**CITY OF CHARLOTTESVILLE
NEIGHBORHOOD DEVELOPMENT SERVICES**

To: City of Charlottesville Planning Commission
CC: Alex Ikefuna, Director
Missy Creasy, Assistant Director
Lisa Robertson, Chief Deputy City Attorney
From: Brian Haluska, Principal Planner
Date: October 8, 2019
Re: Form-Based Code Draft for Phase 1 of the Strategic Investment Area

To: Alex Ikefuna, Director
CC: Missy Creasy, Assistant Director
Lisa Robertson, Chief Deputy City Attorney
From: Brian Haluska, Principal Planner
Date: September 24, 2019
Re: Public Feedback on the SIA Form-Based Code Draft

6.1. BUILDING HEIGHT

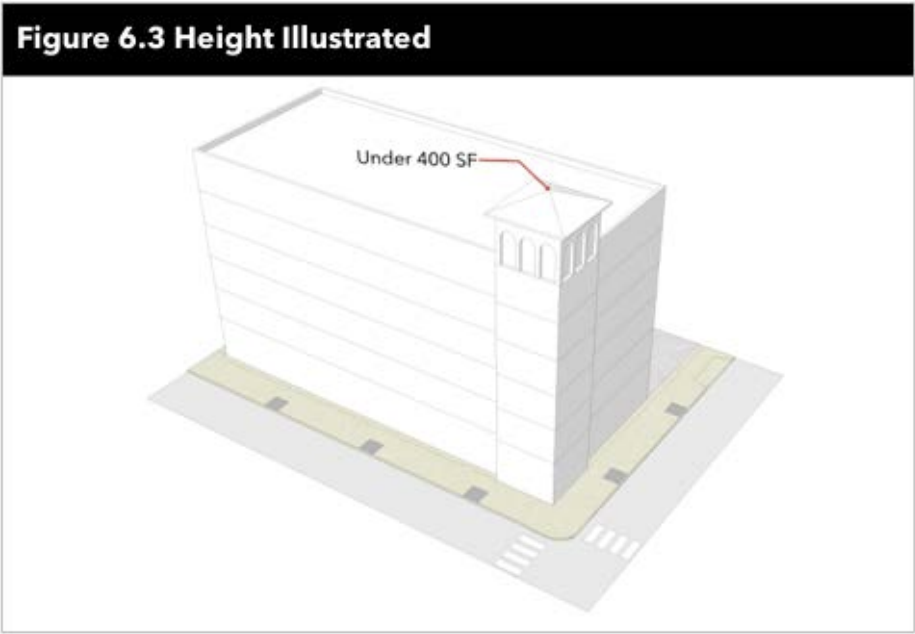
70. *Section 6.* Minimum ground floor heights are referenced but not stated. They are shown as 16’ in figure 6.1. If this is the set minimum, it should also be listed in the text. Does this apply to the T4 transect as well?

71. In figure 6.1, is the 4-5’ dimension between the residential floor slab and the sidewalk elevation an absolute? This may preclude multi-family buildings on sloping sites. How does ADA access work for these units from a shared lobby? Does this figure apply to the T4 transect – if someone wants to build townhouses for instance?
